Large Break LOCA Code Applicability Report for US-APWR

SUBJECT: UNITED STATES - ADVANCED PRESSURIZED WATER REACTOR REVISED
FINAL TOPICAL REPORT SAFETY EVALUATION FOR TOPICAL REPORTS
MUAP-07011-P, "LARGE BREAK LOCA CODE APPLICABILITY REPORT FOR
US-APWR," REVISION 4; AND MUAP-07013-P, "SMALL BREAK LOCA
METHODOLOGY FOR US-APWR," REVISION 3

Docket No. 52-021

Figure 3.3-2 ECCS Flow Injection Performance during LBLOCA

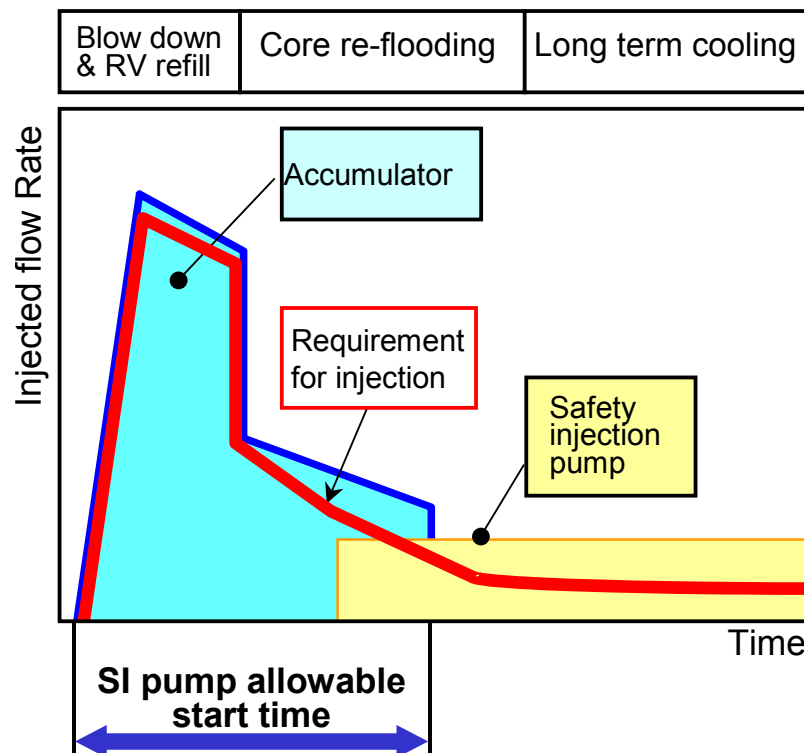
The description in Section 3.3.3 of the topical report "Refilling Period" about the coolant injection through the DVI is not consistent with Table 3.3-1 "Typical Sequence of the LBLOCA of US-APWR" and that illustrated in Figure 3.3-2 "ECCS Flow Injection Performance during LBLOCA". The statement of HHSI in Section 3.3.3 "Refilling Period" should be eliminated, instead should be added to be a part of "Reflooding Period".

The information of Figure 3.3-2 is consistent with the description in Section 3.3.3.

Figure 3.6-15 Hot Assembly Channel Total Flow Rate

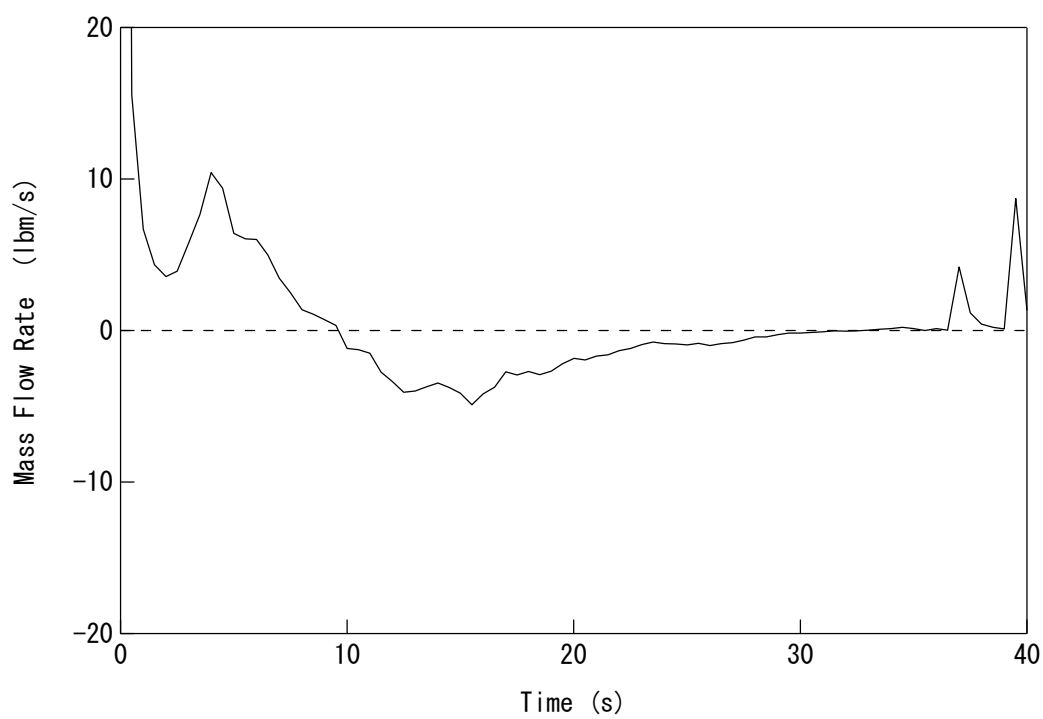
In Subsection 3.6.5.1, the blowdown phase shows hot channel flow rate in Figure 3.61-5. Provide a reference or discussion on why does flow increase around 5 seconds?

Hot channel flow rate is shown in Figure 3.6-15. (not in Figure 3.61-5)

Figure 3.6-18 Downcomer Liquid Level

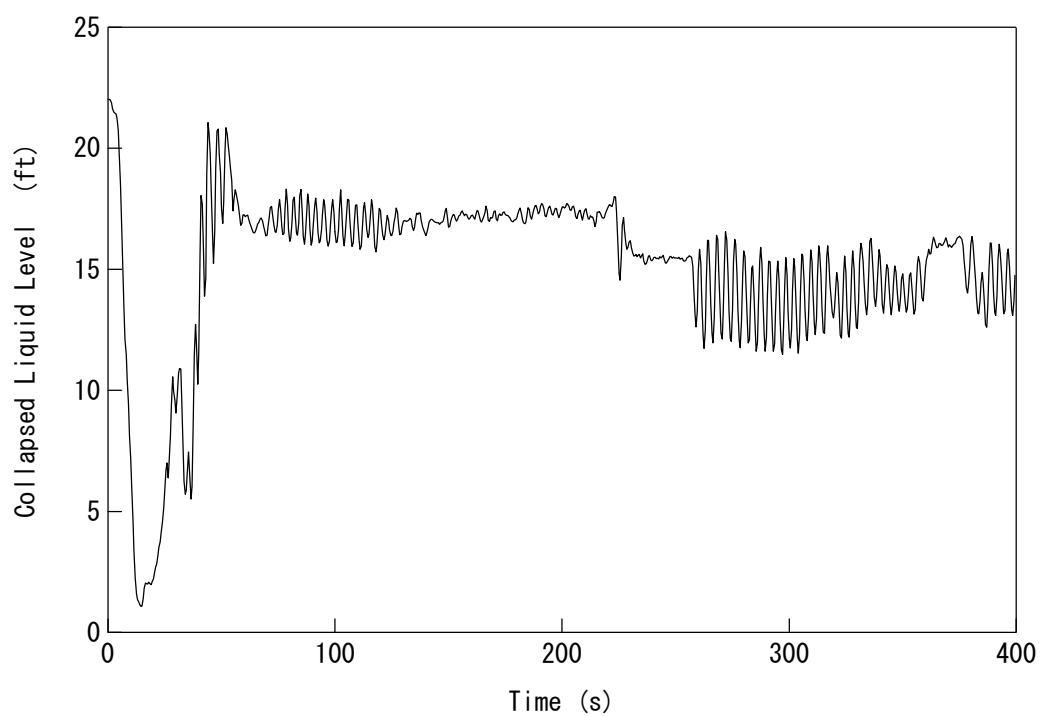
The staff noted that Figure 3.6-18, "Downcomer Liquid Level," showed an oscillatory behavior. The first LBLOCA RAI set, Question 3.10 requested an explanation of the oscillatory behavior, in particular the role of condensation due to direct vessel injection, a phenomenon which is ranked as not applicable. The response to Question 3.10 [Ref. 10] stated that DVI related condensation was rated as not applicable because it occurred after the hot spot in the core had quenched. When DVI was initiated (125 s) the downcomer level was high enough to cover the DVI nozzles, so no steam condensation was occurring due to DVI. Only after the accumulators emptied did the downcomer level drop below the DVI nozzles, but by this time the core had

The description of refill phase indicates that this phase ends when the downcomer is full. Figure 3.6-18 indicates that the downcomer level is less than the level at the beginning of the transient when the downcomer is filled with liquid. Provide a reference or explanation of the ending of refill phase.

"In this phase, the core heat-up continues when the lower plenum is filled with the advanced accumulator injection water. Figure 3.6-17 shows the lower plenum collapsed liquid level. When the advanced accumulator injection water fills the lower plenum and begins to enter the core, the refill phase ends."
